Our Ref: 04B819288
Your Ref: PP-09576603

PLANNING APPLICATION TO VARY AN EXISTING CONDITION UNDER SECTION 73 OF THE TOWN AND COUNTRY PLANNING ACT: PLANNING PERMISSION REF. 3/2019/0953, RESIDENTIAL DEVELOPMENT AT STANDEN PHASES 2, 3 AND 4

Ground Floor Plan

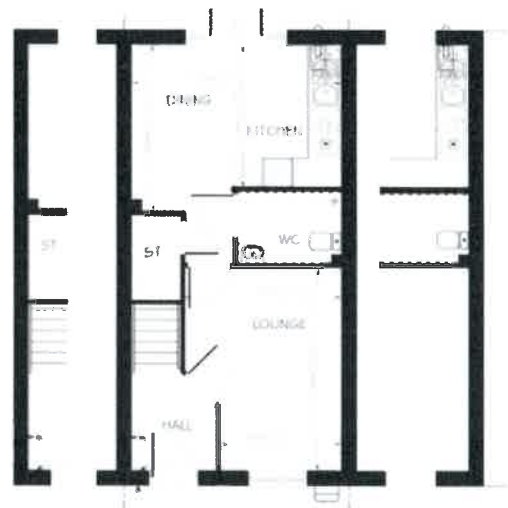
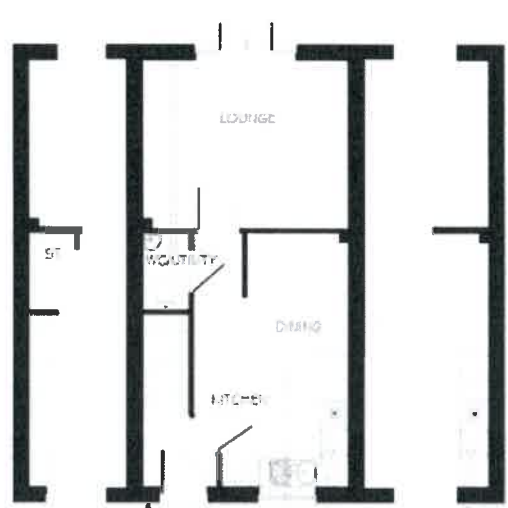
The only difference between the two house types is the internal layout of the ground floor, as indicated below. The position of the kitchen and dining area has swapped with the lounge area; the first floor layout remains as is; and the stand-in wardrobe has been removed from the second floor.
